FINAL ENVIRONMENTAL IMPACT REPORT

SANTA ANA RIVER WATER RIGHT APPLICATIONS FOR SUPPLEMENTAL WATER SUPPLY

January 2007
SCH# 2002071062

Figure 3.1-9. Probability of Daily Discharge for SAR Segment D, below Mill Creek, WY 1966-67 through WY 1999-2000

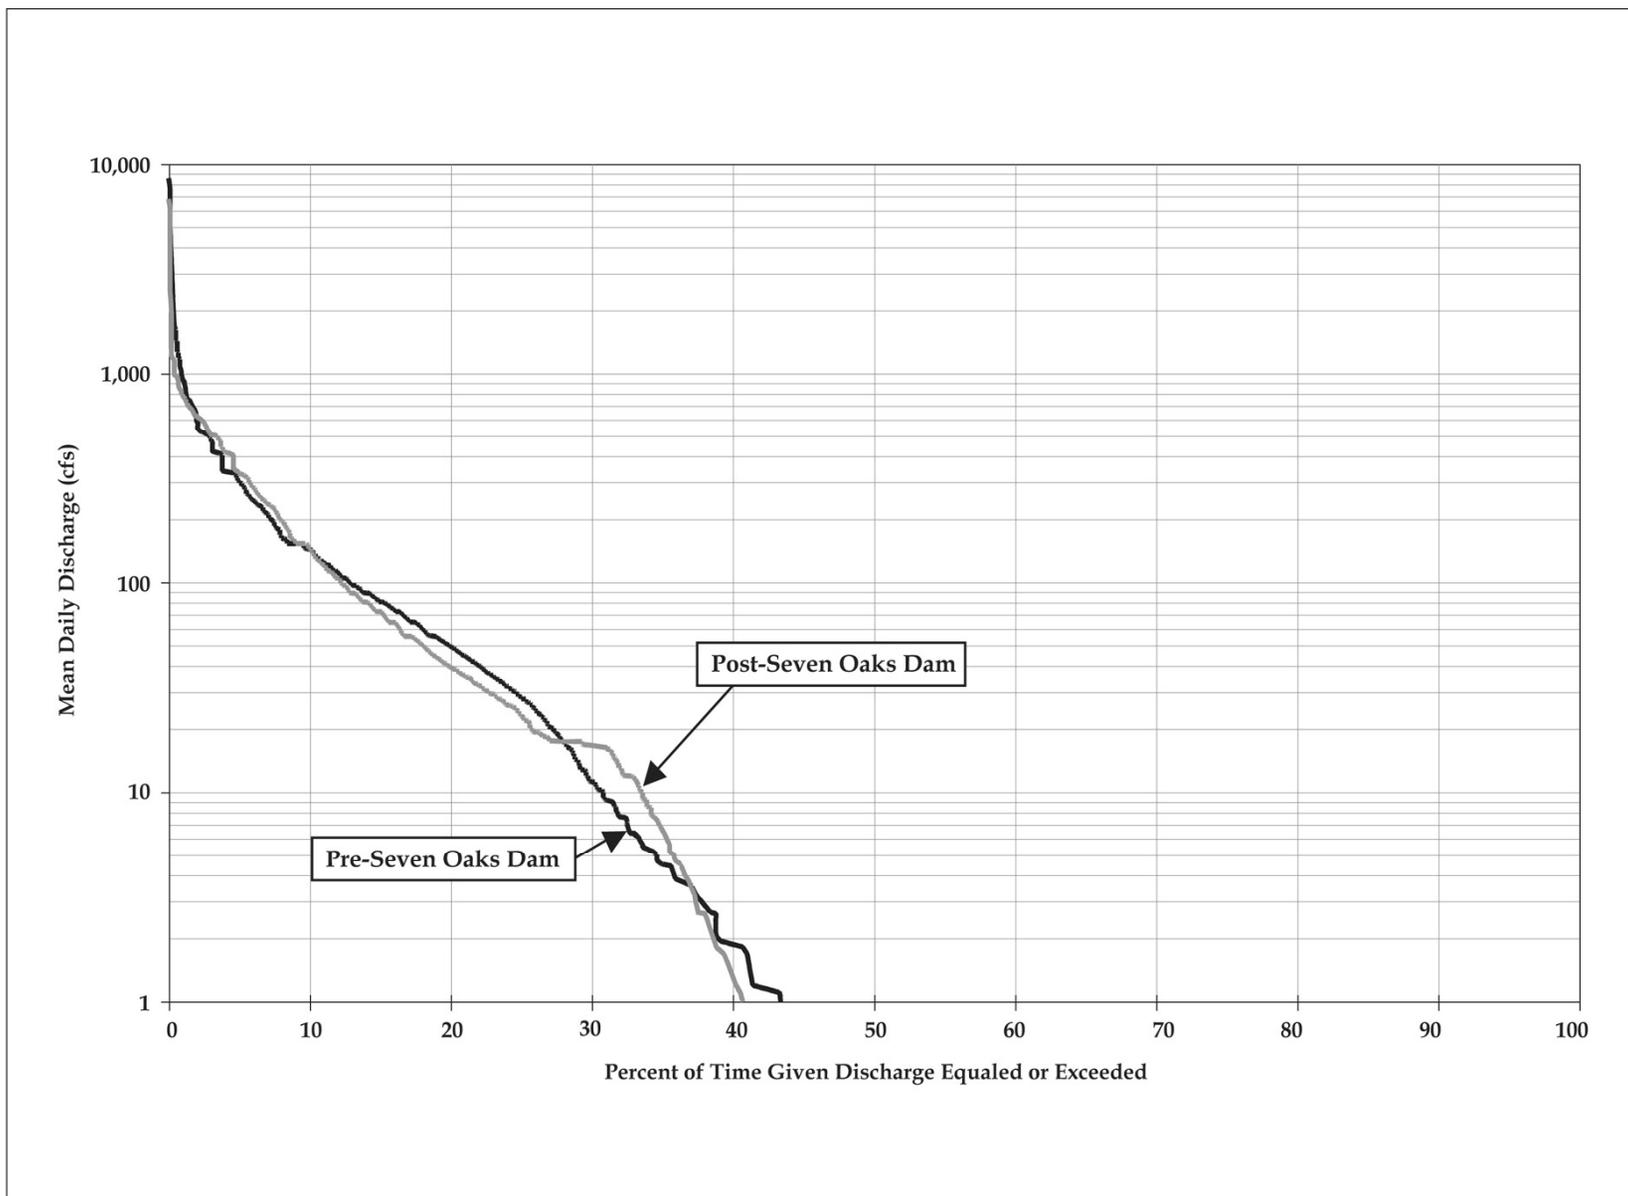
15 Figure 3.1-9 of the Draft EIR shows probability of exceedances curves for flow below the confluence
16 of Mill Creek. [Note to the reader: due to refinements in the modeling, Draft EIR Figure 3.1-9 has
17 been replaced. See the replacement figure provided in Appendix A of this Final EIR.] These curves
18 are estimated based on nearby gage data with adjustments made for diversions and other losses as
19 well as inflow. This figure shows that prior to the construction of Seven Oaks Dam, no flow
20 occurred in this segment about 55 percent of the time, flows above 10 cfs occurred approximately 35
21 percent of days, and flows above 100 cfs occurred approximately 15 percent of the time. With the
22 dam in operation, flows are similar to those of pre-dam conditions, demonstrating that the inflow
23 from Mill Creek lessens the influence of flows from the Project area in this segment. With the dam
24 in operation, virtually no discharge occurs in this river segment approximately 58 percent of the

Figure 3.1-10. Probability of Daily Discharge for SAR Segment E, below "E" Street Gage, WY 1966-67 through WY 1999-2000

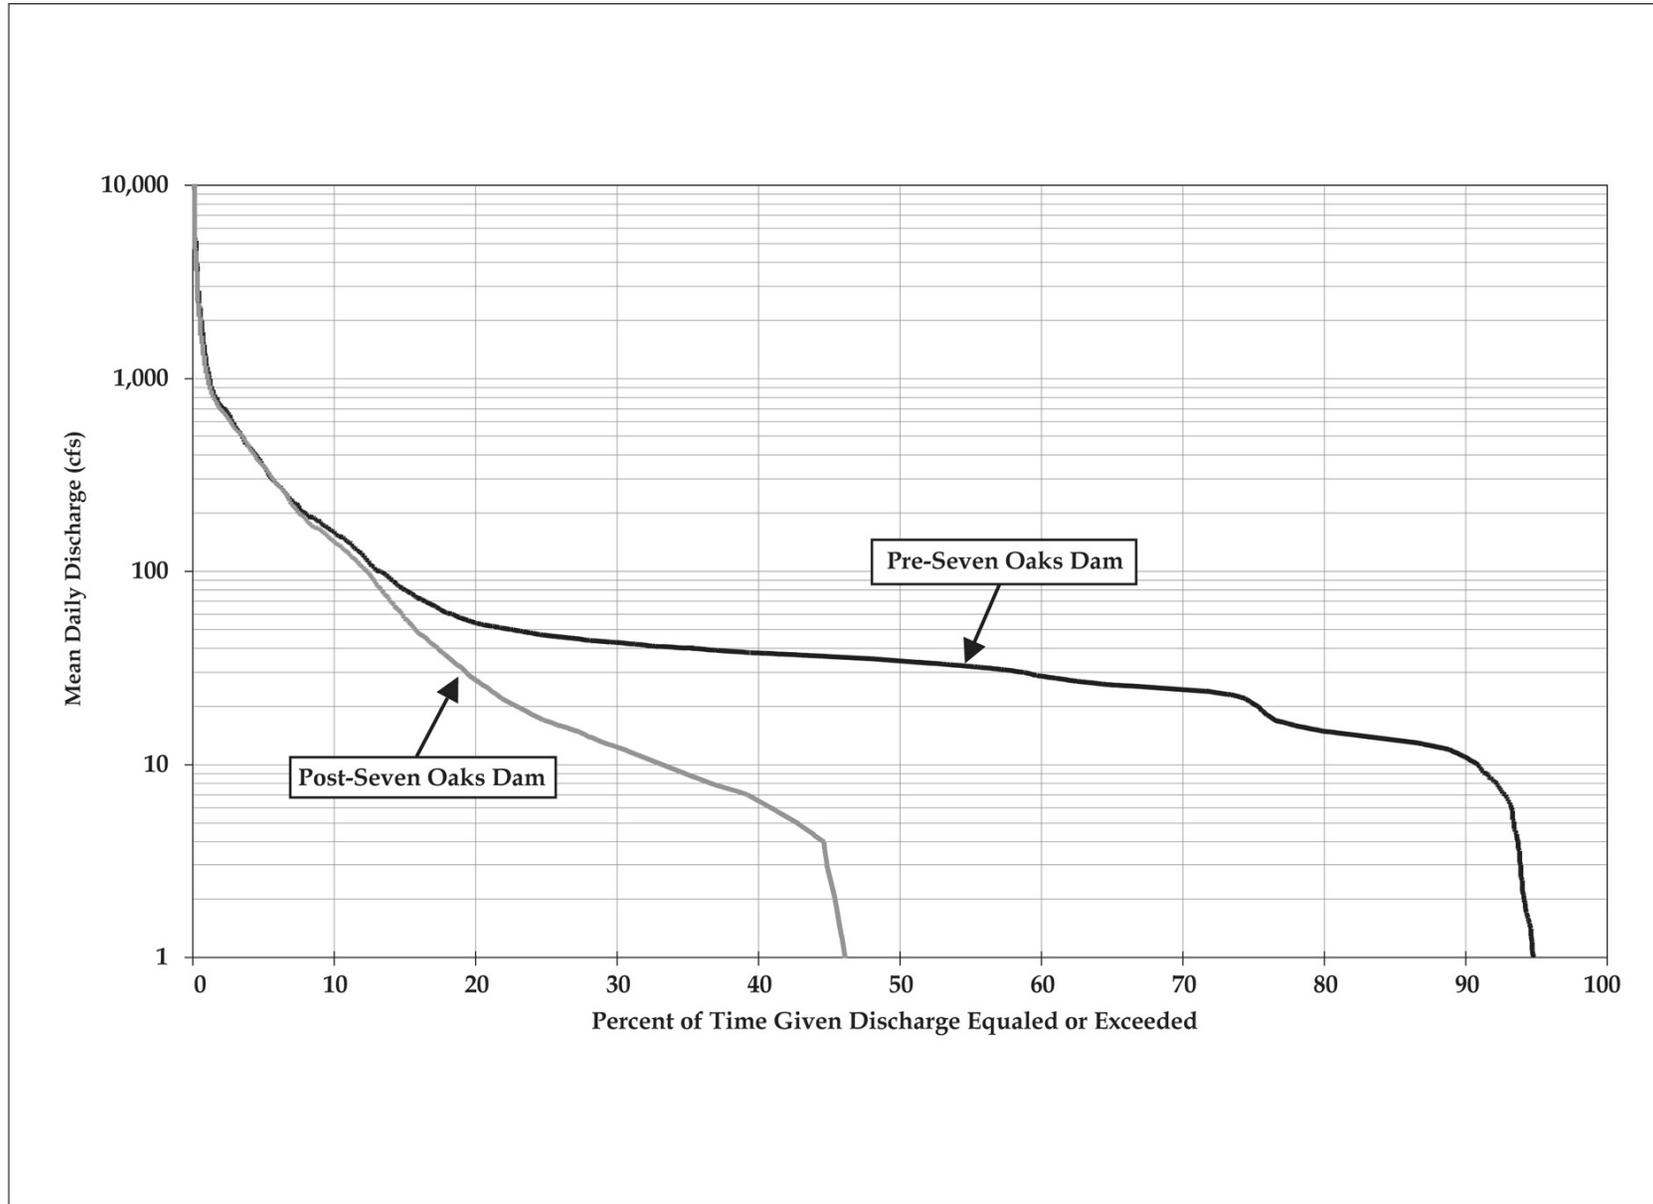
36 Draft EIR Figure 3.1-10 presents probability of exceedance curves for flow downstream of "E"
37 Street. [Note to the reader: due to refinements in the modeling, Draft EIR Figure 3.1-10 has been
38 replaced. See the replacement figure in Appendix A of this Final EIR.] Prior to the construction of
39 Seven Oaks Dam, no flow was present in this segment about 5 percent of the time, flows above 10
40 cfs occurred approximately 90 percent of days, and flows above 100 cfs occurred approximately
41 13 percent of the time. With the dam in operation, flows are consistently lower than under pre-
42 dam conditions, but this effect is due largely to the loss of WWTP effluent that, prior to 1996, was
43 discharged into this river segment but is now discharged into Segment F. Currently, no flow
44 occurs in this river segment approximately 54 percent of the time, flows above 10 cfs are equaled

Figure 3.1-11. Probability of Daily Discharge for SAR Segment F, below RIX and Rialto Effluent Outfall, WY 1966-67 through WY 1999-2000

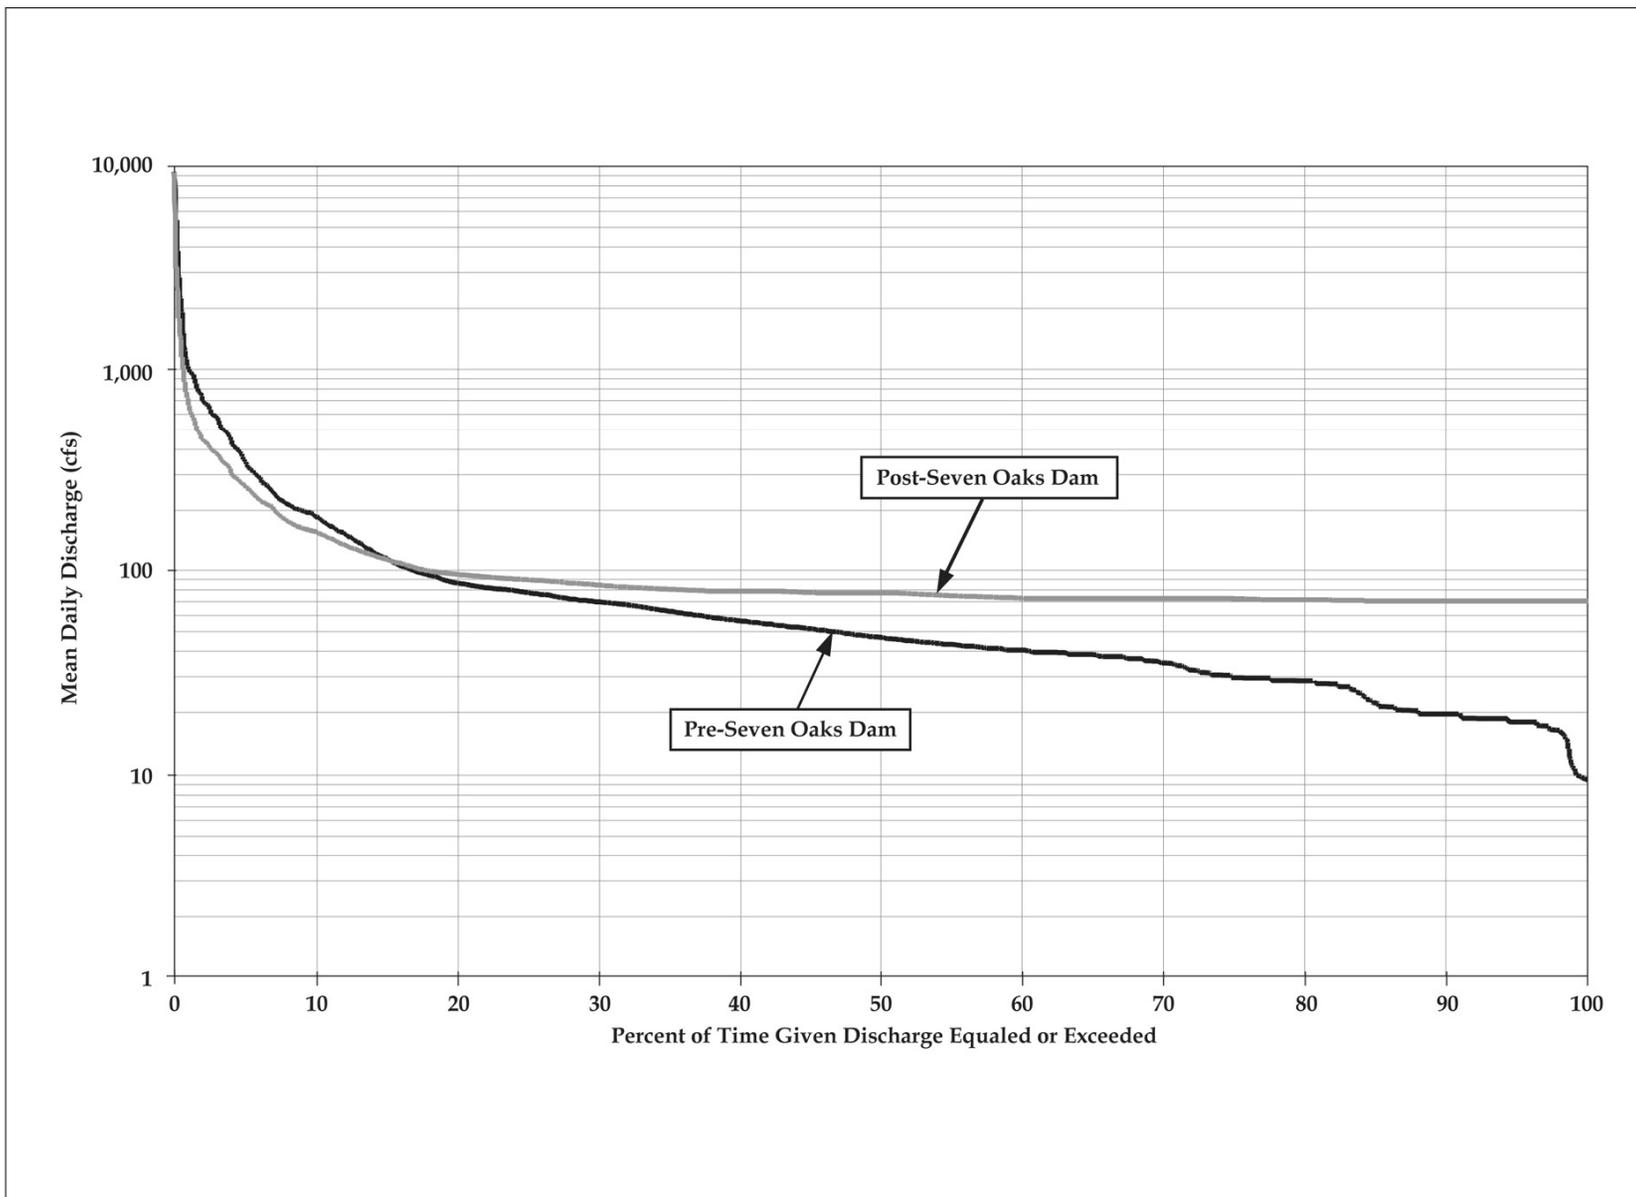
11 Draft EIR Figure 3.1-11 presents probability of exceedance curves downstream of the RIX and
12 Rialto effluent outfalls. [Note to the reader: due to refinements in the modeling, Draft EIR
13 Figure 3.1-11 has been replaced. See the replacement figure in Appendix A of this Final EIR.]
14 They vary from the curves shown for the upstream segments and illustrate the presence of
15 higher and more sustained flows below the outfalls. This figure shows that, prior to the
16 construction of Seven Oaks Dam, flows equaled or exceed 10 cfs at all times. With the dam in
17 operation, flows are consistently higher than under pre-dam conditions, but this effect is due
18 largely to the addition of WWTP effluent that, prior to 1996, was discharged in Segment E.
19 Since 1999, discharge in this river segment has equaled or exceed 60 cfs at all times.
